Public and Agency Comment Summary

This chapter summarizes comments received on the East Link Project Draft Environmental Impact Statement (Draft EIS) and the Supplemental Draft EIS (SDEIS). It is intended to serve as a summary only; it is not intended to address every comment received during the Draft EIS and SDEIS comment periods. All comments received and responses to those comments are included in Appendix J of this Final EIS.

Exhibit 7-1
B7/B7R
Segments B and C
 East Link Project

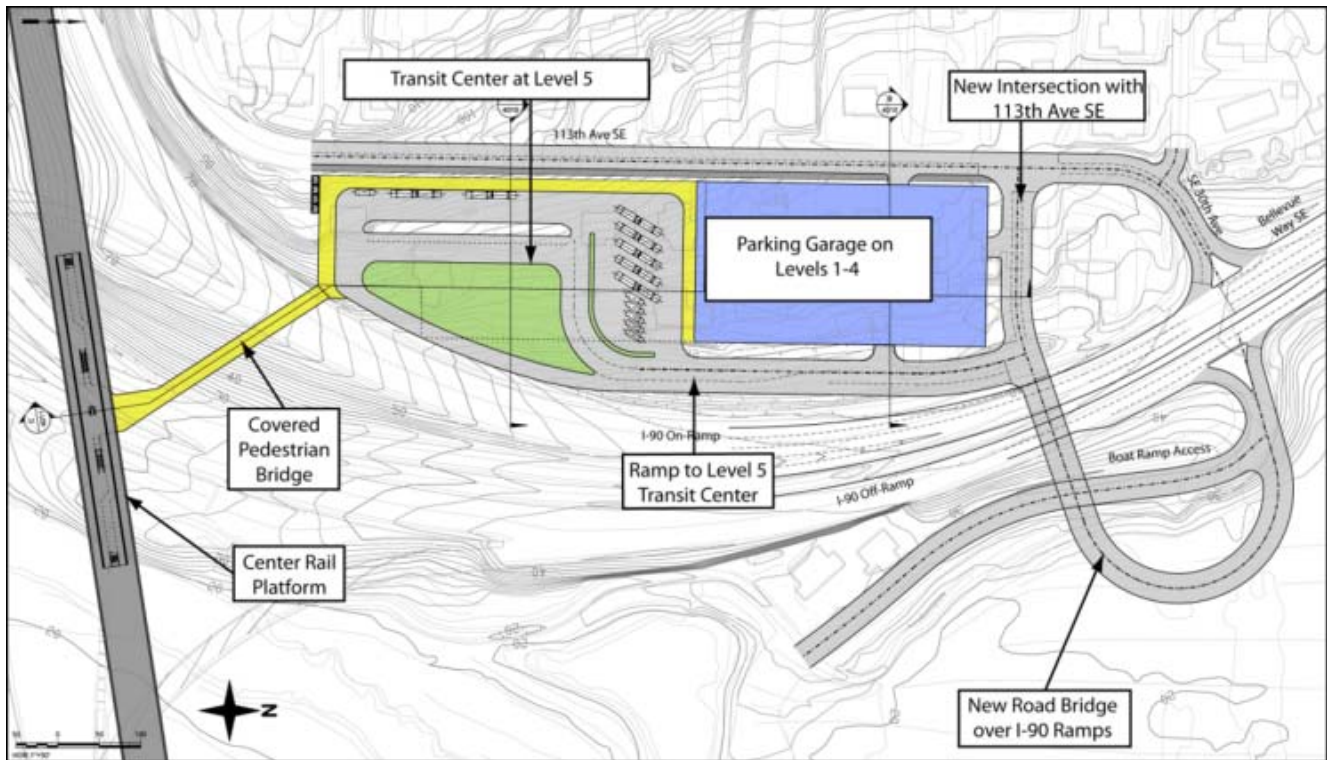
- B7R includes two options for accommodating the former BNSF Railway corridor's "railbanked" status. One option assumes joint, or shared use of tracks by light rail and freight or commuter rail trains, which is inconsistent with Sound Transit's design criteria. The second option accommodates space for future freight rail operations with an interim trail use, more consistent with Sound Transit's current design in the corridor.

- B7R is designed to connect to a revised Alternative C9T which would cross under Main Street, begin the tunnel portal north of Main Street and turn west at NE 2nd Street instead of Main Street, where *Preferred Alternative C9T* enters a tunnel portal.
